SUNDRY NOTICES AND REPORTS ON WELLS
Do not use this form for proposals to drill or to re-enter an abandoned well. Use form 3160-3 (APD) for such proposals.

Ridgeway Arizona Oil Corp (Ridgeway) requests approval to plug and abandon the Farrell Federal #15 according to the attached proposed plugging procedure and well bore diagram.

Plugging Procedure
Farrell Federal #15
API - 30-041-10433
Sec. 28, T7S, R33E, UL-B
660' FNL 1980' FEL

**Farrell Federal 15
30-041-10433
Ridgeway Arizona Oil Corp
November 21, 2017
Conditions of Approval**

Co. Rep	0
Well Name	Farrell Federal Well No. 15
Field	Chaveroo San Andres
County	Roosevelt
State	NM
Date	
Date Comp	
KB	4414 RDB

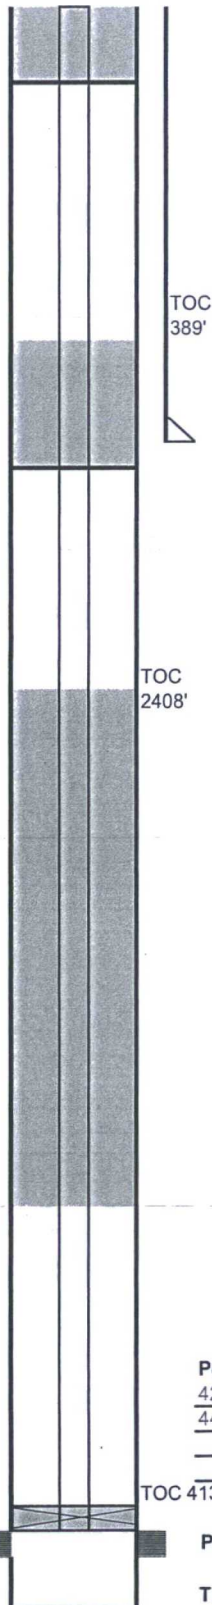
salt plug added / plugs altered

1. Prepare location and test anchors
2. MIRU plugging rig
3. Notify OCD/BLM 24 hours prior to commencement of P&A procedures
4. NDWH/NU BOP
5. RIH w/ 4 1/2" CIBP on 2 3/8" workstring @ 4168' (+/-) *4163' (50' below top most perf)*

- a. Bleed pressure off after MIT
7. MIRU WL and RIH w/ perf gun to 2533'
 - a. Perforate @ 2 JSPF
 - b. POOH w/WL
 - c. RDWL
8. TIH w/WS - Squeeze 125' cement @ 2533' to 2408' (+/-) *2200' (to seal top of the Yates)*

- a. Wait on cement
 - b. Tag plug @ 2408' or above
9. MIRU WL and RIH w/perf gun to 539' ** salt plug added see COAs*
 - a. Perforate @ 2 JSPF
 - b. POOH w/WL

- c. RDWL
10. TIH w/WS - Squeeze 100' cement @ 489' to 389' *384' (50' below + 50' above shoe)*
 - a. 8 5/8" casing shoe @ 414'
 - b. Wait on cement
 - c. Tag plug @ 389' or above

- 1. Operator shall place CIBP at 4,163' (50'-100' above top most perf) and place 35' of Class C cement on top as proposed. WOC and TAG.**
- 2. Operator shall perf and squeeze at 2,533'. Operator shall place a balanced Class C cement plug from 2,533'-2,200' to seal the top of the Yates formation. WOC and TAG.**
- 3. Operator shall place a Class C cement plug from 1,900'-1,700' to seal the salt.**
- 4. Operator shall perf and squeeze at 489' as proposed tagging plug at 364' to seal the surface shoe. WOC and TAG.**
- 5. Operator shall shall perf and squeeze at 60' brining cement to surface.**
- 6. See Attached for general plugging stipulations.**
